## PUBLIC UTILITIES COMMISSION

**RE: Mesa 500-kV Substation Project – Minor Project Change No. 13 Request:  
Transmission tower relocation**

**Attachment A:  
MPC No. 13 Request Figures and Work Area Photos**

## FIGURE 1

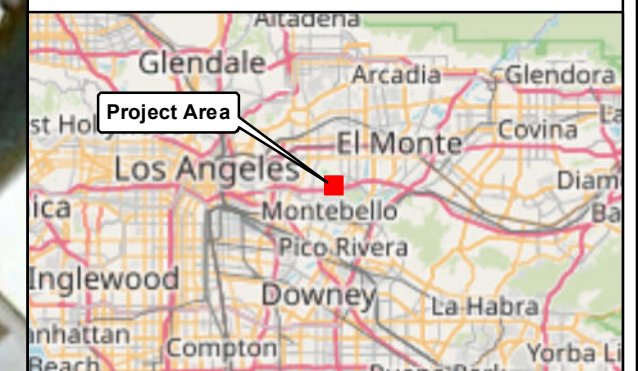
The position of the construction of the LST at Construct 5002 is unchanged.

Work associated with the construction of the LST at Construct 5001 is within the previously approved footprint of the substation grading areas, which are already disturbance areas.

This is the previously approved position of the construction of the LST at Construct 5001.

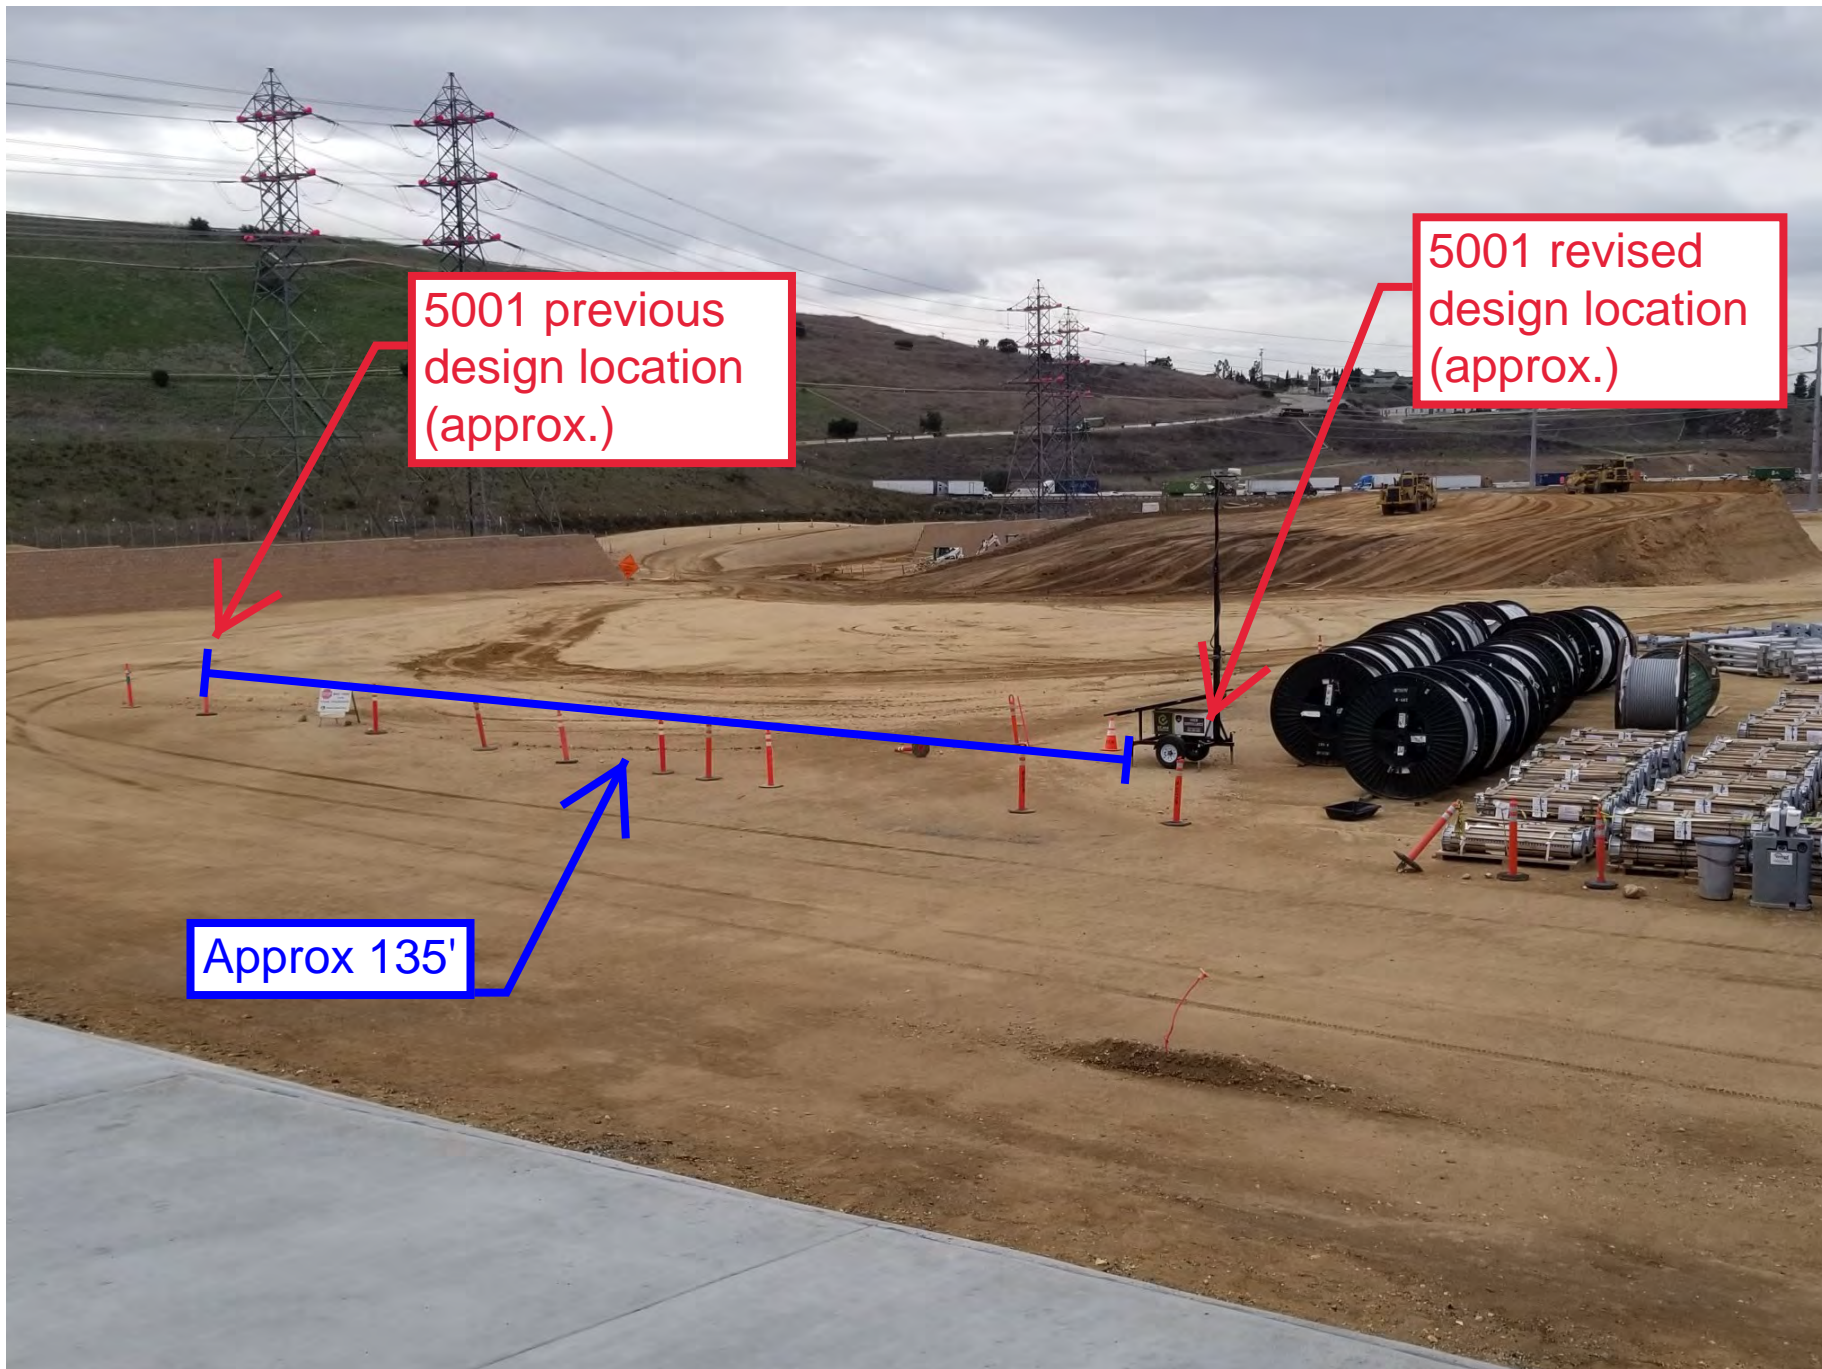
5001 revised design location (approx.)

5001 previous design location (approx.)

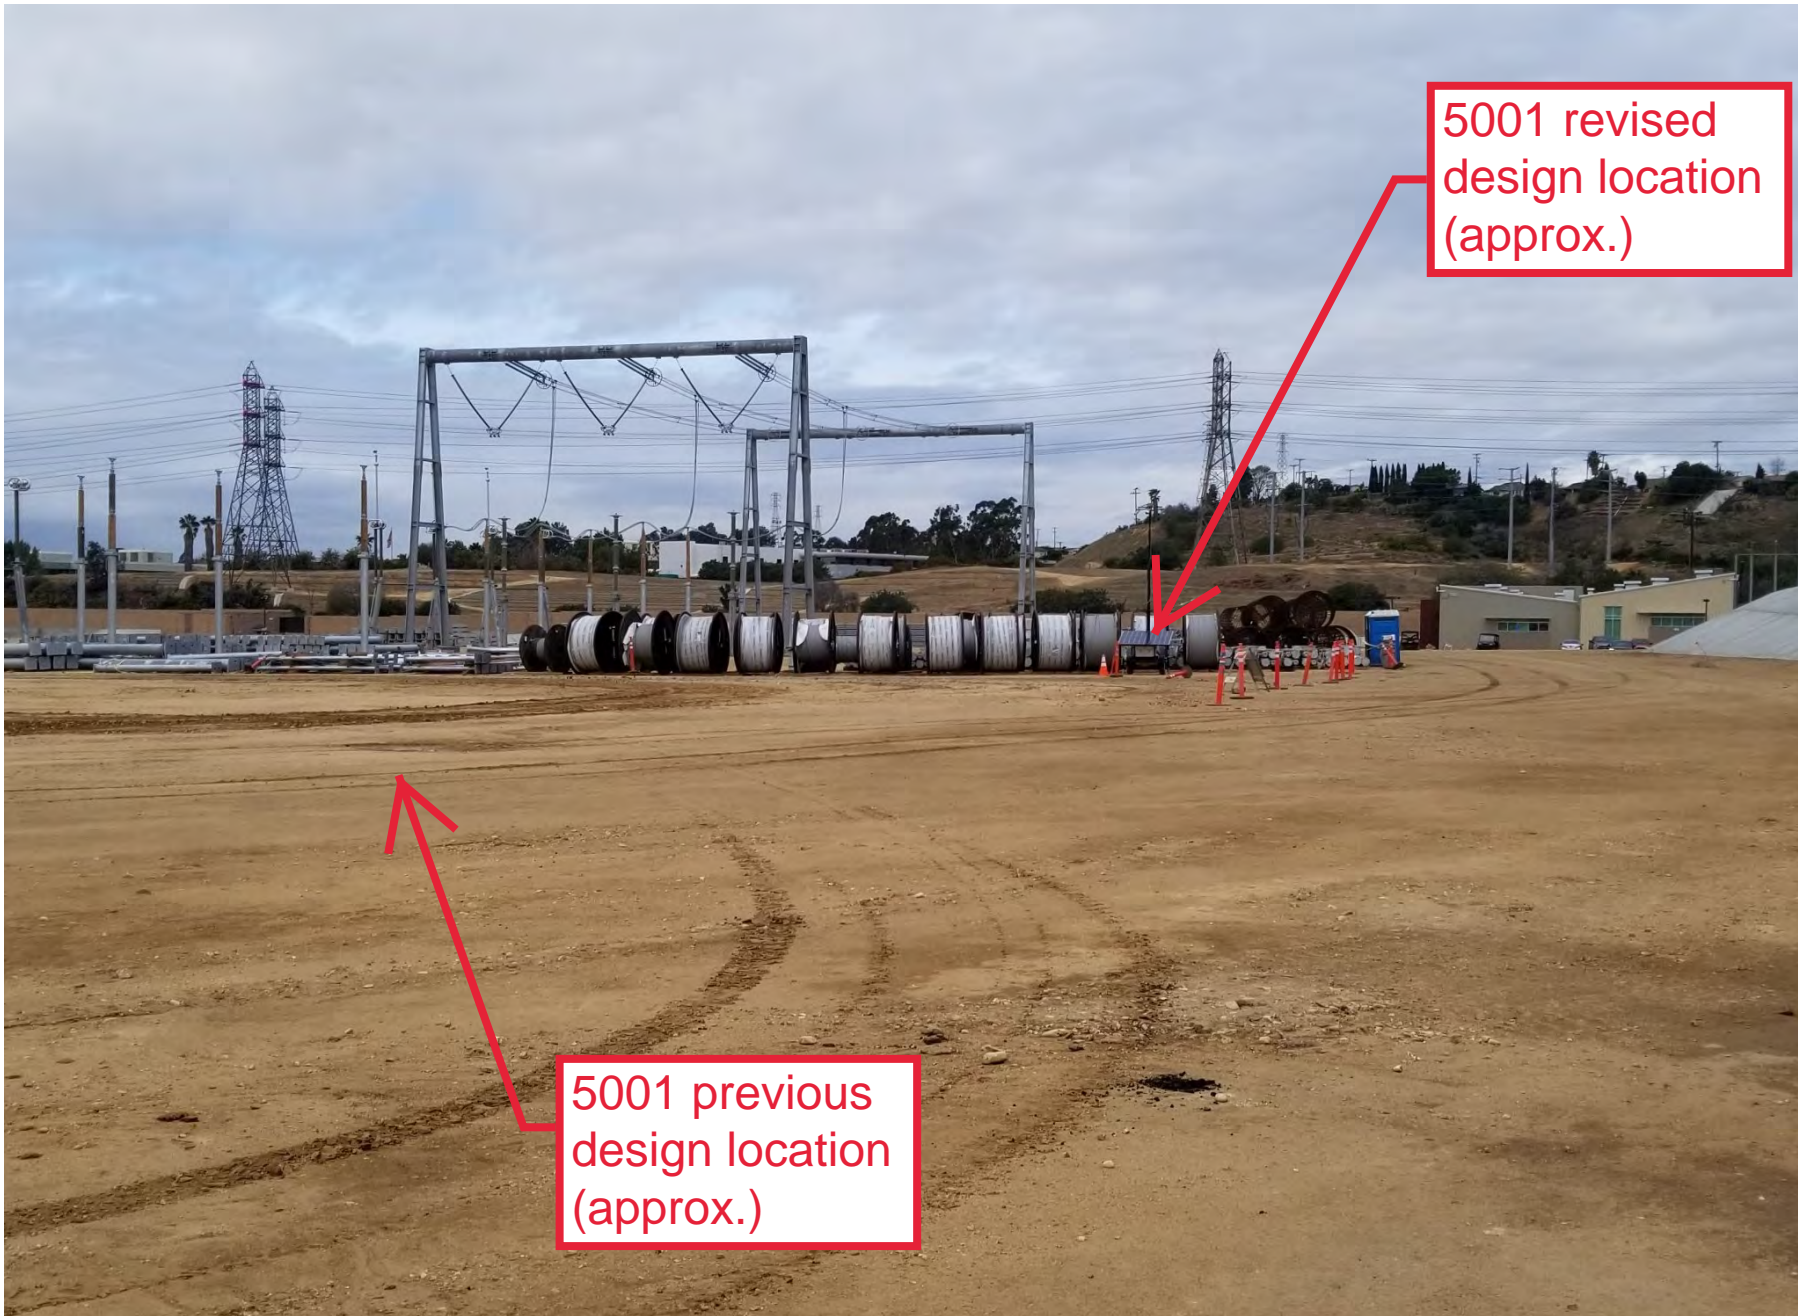
Approx 135'

5001 revised  
design location  
(approx.)

5001 previous  
design location  
(approx.)
